RE: Variance for Decks at 773 Rolling View Drive, Annapolis, MD

PARTIAL TOPOGRAPHY SURVEY
LOT 64
SECTION 1 - BLOCK G
773 ROLLING VIEW DRIVE
CAPE ST. CLAIRE
3rd District, Anne Arundel County, Md.
See Plat Records A.A. Co.
Plat Book 22 Page 20
Scale: 1"=30' Date MAY, 2024

CONFIRMATION OF PRE-FILE

PRE-FILE #: 2024-0035-P
DATE: 04/25/2024
OPZ STAFF: Jennifer Lechner
Kelly Krinetz

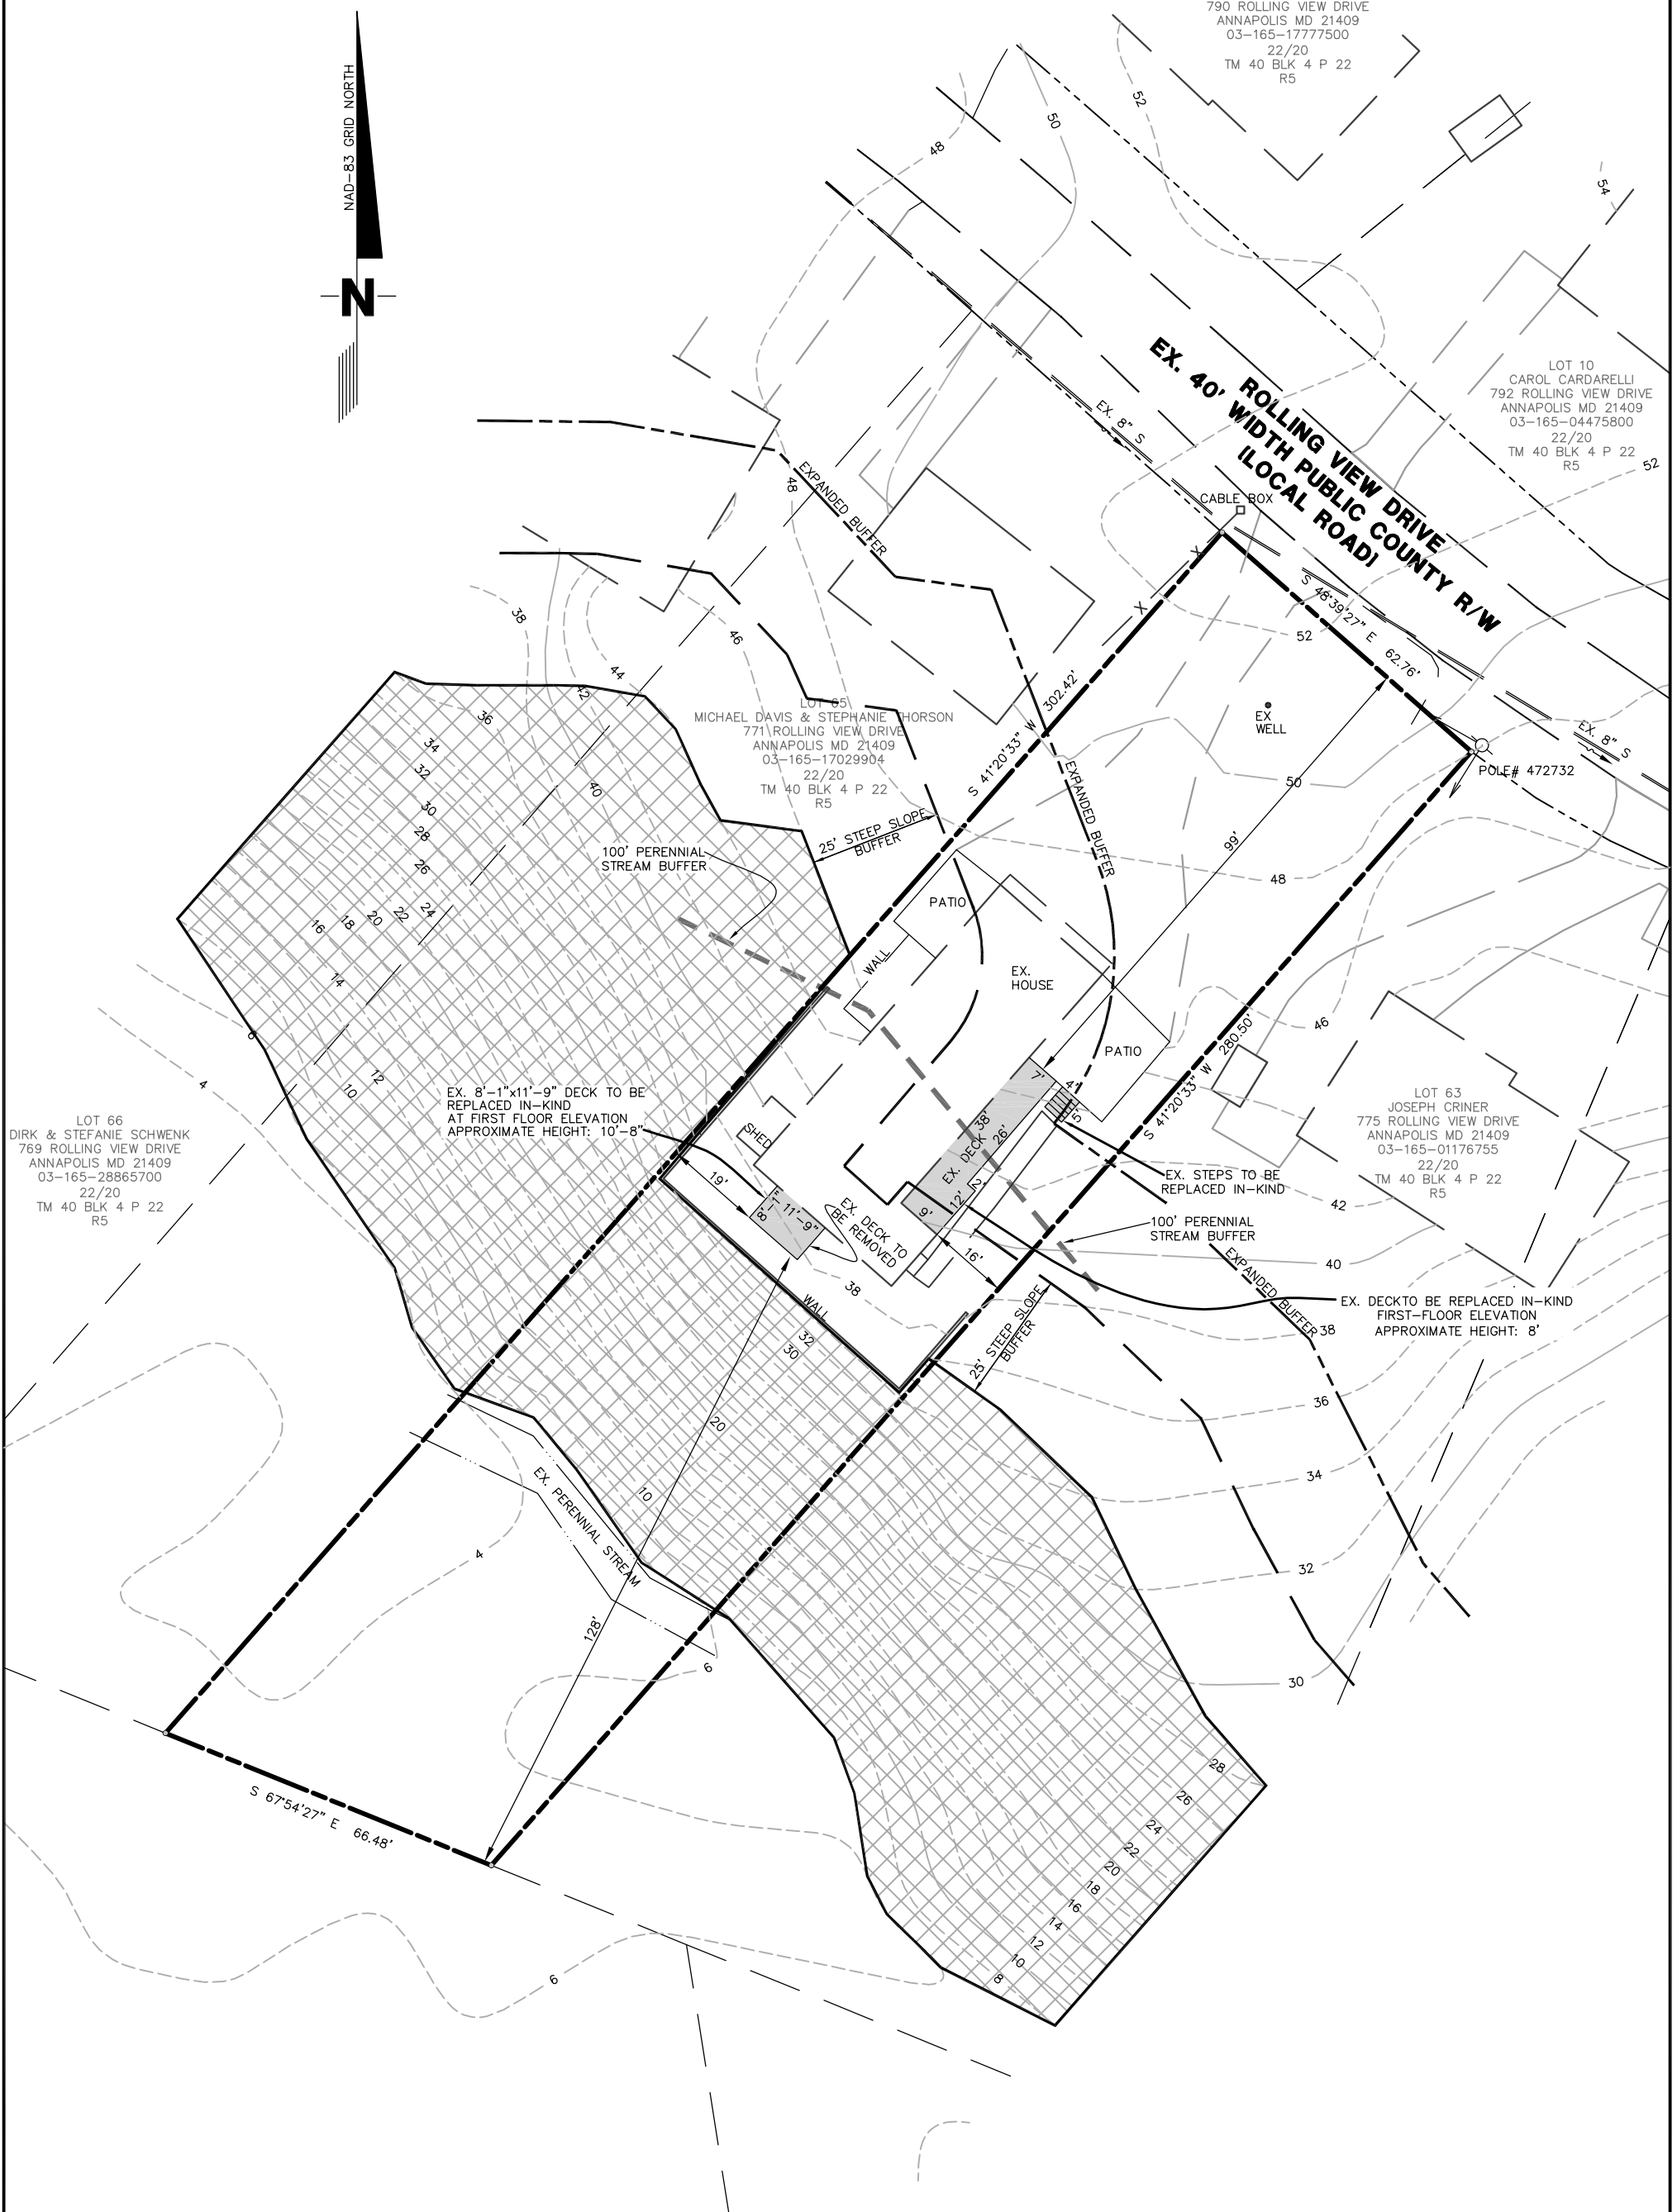
Prior to submission of the variance, revise the Administrative Site Plan to correctly identify the expanded buffer (50 feet from the top of the slopes). In addition, please revise the site plan to include the dimensions of the decks, the setback dimensions of the decks from all property lines, and the height/floor level of the proposed decks.

The Letter of Explanation appears to contradict the Administrative Site Plan. The letter states that "Plans for the back deck hug the house and do not expand the size towards the retaining wall." However, the site plan appears to show that the existing deck to be removed is smaller than and within the footprint of the proposed deck, which does appear to be closer to the retaining wall.
